**Subject: Palm Beach County Request for Independent Scientific Resolution Panel (ISRP)**

## **RE: MODELING SUPPORT FOR APPEAL OF FEMA FLOOD MAPS**

Figure 1 - Proposed Base Floor Elevation in Larger Font (Existing Base Floor Elevation in Small Font)

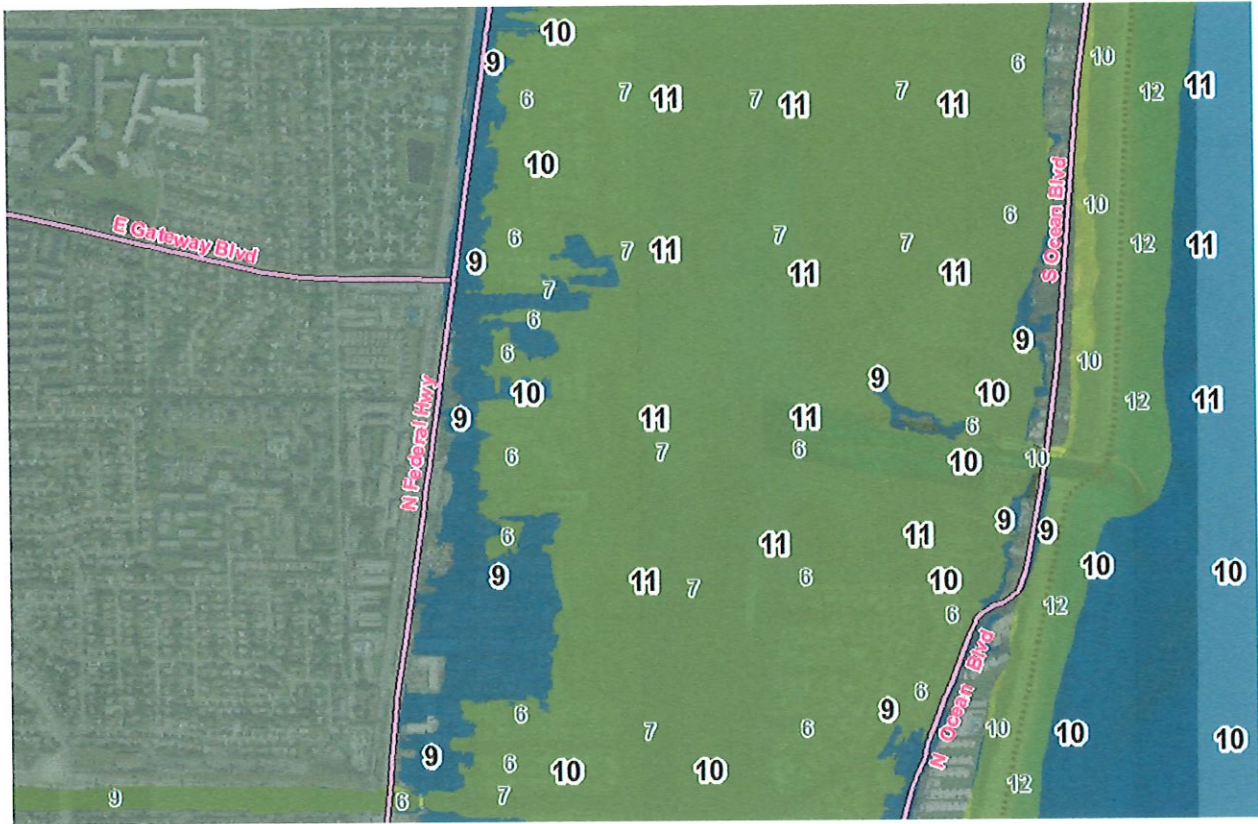
PBC identified multiple modeling issues that are resulting in anomalously high BFEs and incongruent BFEs. We include three examples in this letter. The W.F. Baird & Associates (Baird) Modeling Support for Appeal of FEMA Flood Maps letter dated January 30, 2023 provides a summary of the substantive modeling issues identified in the appeal. The appendices include a list of PBC's appeal submittals. Figures 1 and 2 show examples where the proposed BFEs are 2 to 4 feet higher than the existing BFE. Figure 3 shows how the BFEs are 1) not consistently higher near the inlets, as would be expected from storm surge, 2) the rise of the BFEs at the inlets are not similar even though the inlets have similar capacity, and 3) the BFE are not consistent (dropping and rising). There are likely multiple modeling issues that have interacted/compounded to result in the anomalous results. PBC's coastal engineering consultant (W.F. Baird & Associates) expended considerable effort in trying to identify the causes of the anomalous BFE and provide a "corrected" model. Due to the complexity of the problem, limited time, and limited resources to explore the modeling issues, Baird was unable to provide examples of fully "corrected" modeling runs and the resulting updated FIRMs. While it would have been preferable for FEMA and PBC if "corrected" modeling and FIRMs were achieved, it is PBC's opinion that with the complex modeling issues identified, that providing a "corrected" model should not be a requirement for justifying that the model requires additional work.

Figure 1: Water Surface Elevation – Boynton Inlet – Synthetic Storm #21

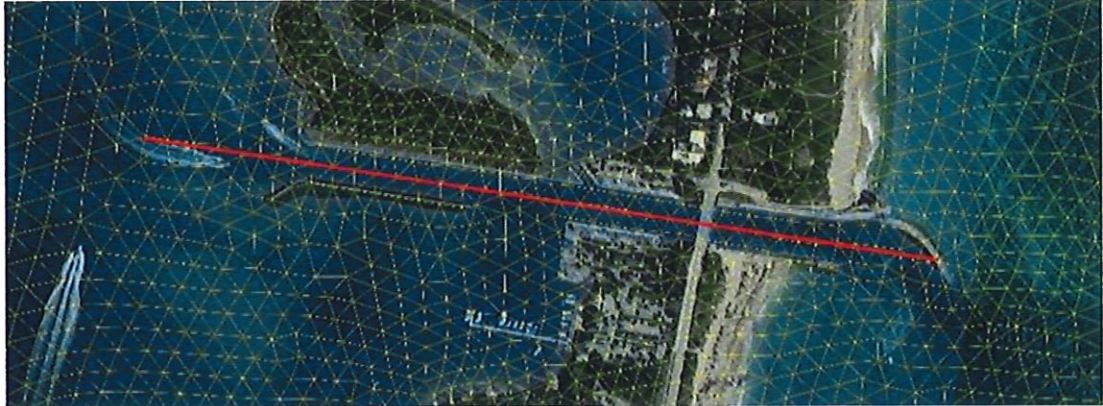
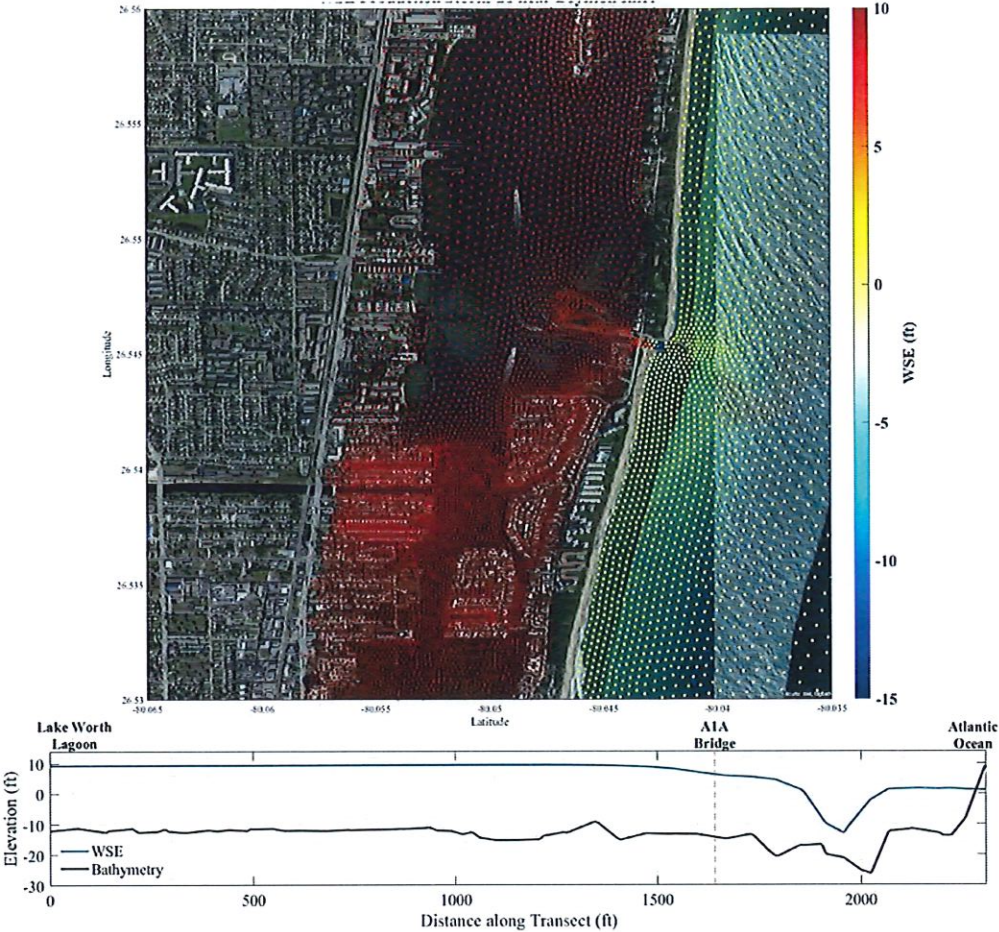
There is a 20-foot drop in the water level within Boynton Inlet from approximately +10 feet, NAVD88 to -10 feet, NAVD88 before it increases by 14 feet to +2 feet, NAVD88 elevation offshore! The drop occurs over 400 feet and the rise occurs over 100 feet (Figure 1). This is clearly not hydrodynamically possible.

During the synthetic storm (#21) that produced the highest WSE within this area of the lagoon, FEMA's model did not allow water to flow out through the inlet. This created unrealistic WSE changes in the inlet thereby affecting WSE within the lagoon as the storm passed to the north. Initially, Baird revised the model grid to include additional nodes across the inlet because it was surmised that the wetting/drying of nodes within the

SWAN+ADCIRC model combined with insufficient mesh resolution could have contributed to the unrealistic WSE changes. While we were unsuccessful in resolving this issue in the time we had available, we recommend that a water balance box model be considered to better understand how the model is predicting water inflows into the lagoon.
